From: [Bob](#)
To: [Rykaart, Maritz](#)
Cc: ["Calvin G."; "Rustad, Bruce"](#)
Subject: Hope Bay. Pad Q. Design
Date: Thursday, June 16, 2011 4:04:09 PM
Attachments: [sk0020100350009\(pad Q\).pdf](#)

PROCESS BUILDING GENERAL SITE PLAN

SK20-10-035-0009

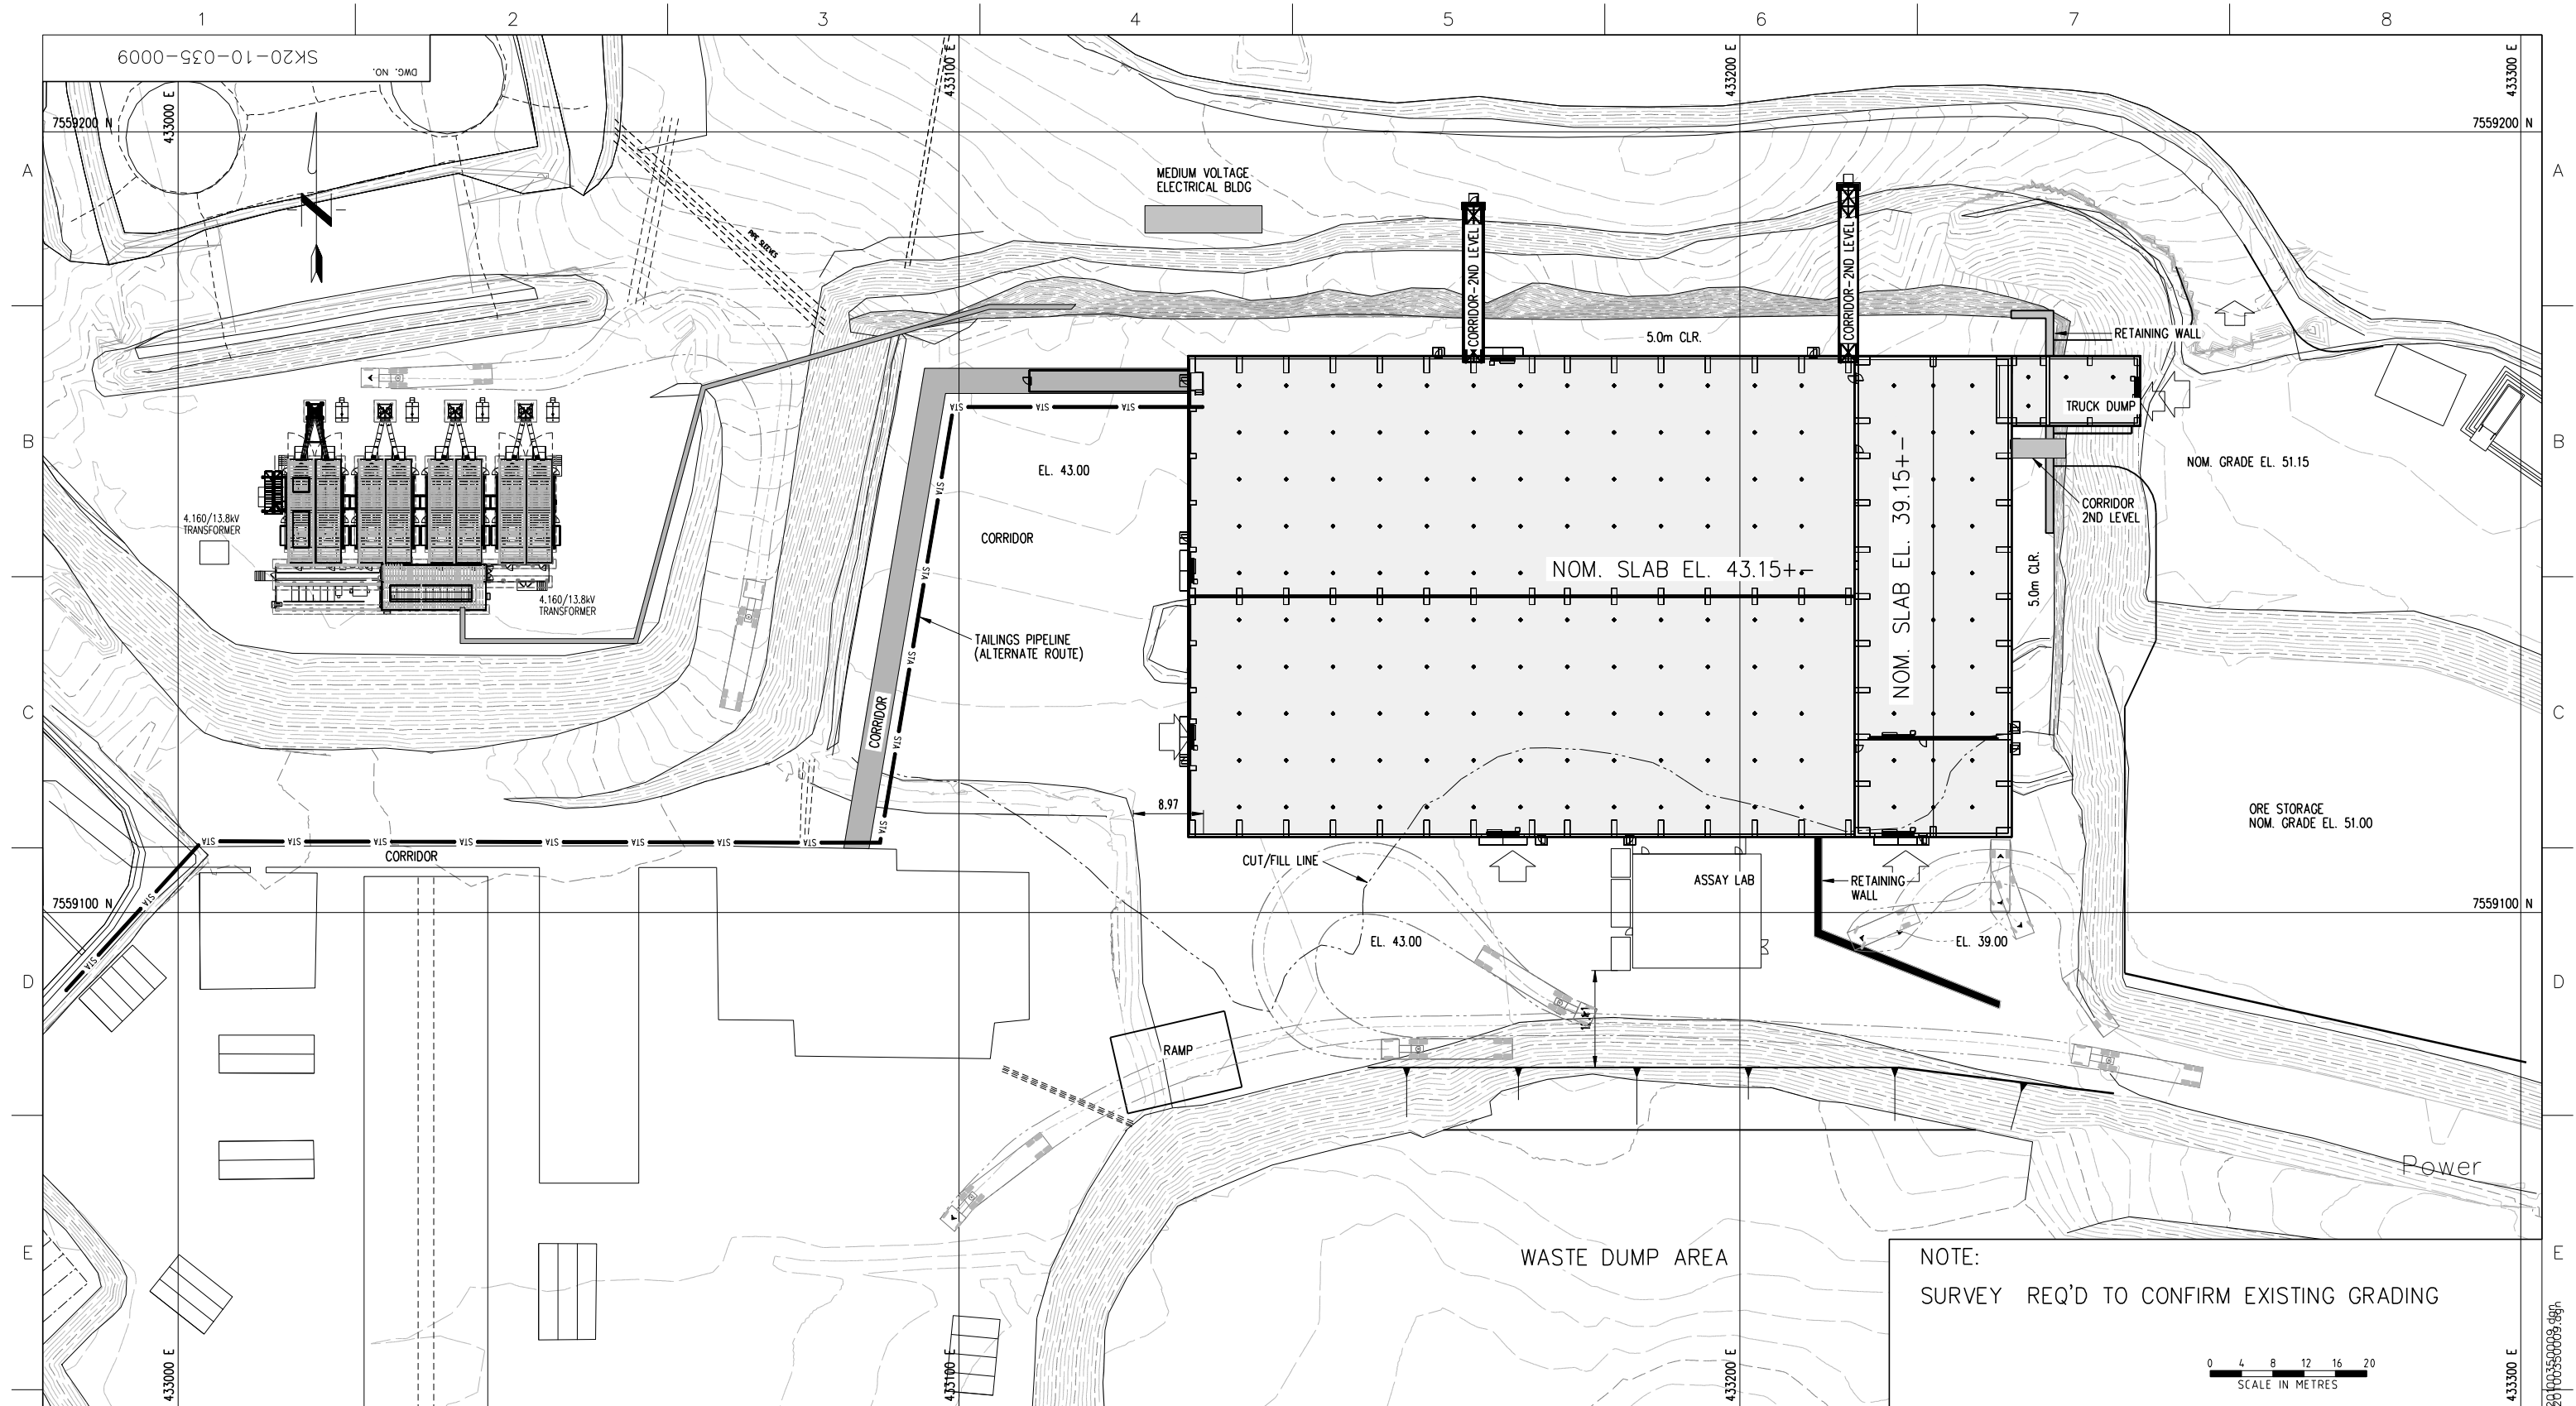
Hi Maritz. Attached is a pfd of the site plan with the process plant added in for clarity.
In my opinion the retaining wall should be extended south by say another 10 m to give us a bit more area at the truck dump level.
Please modify your dwgs. and proceed with the most cost effective design of the wall
Regards, Bob
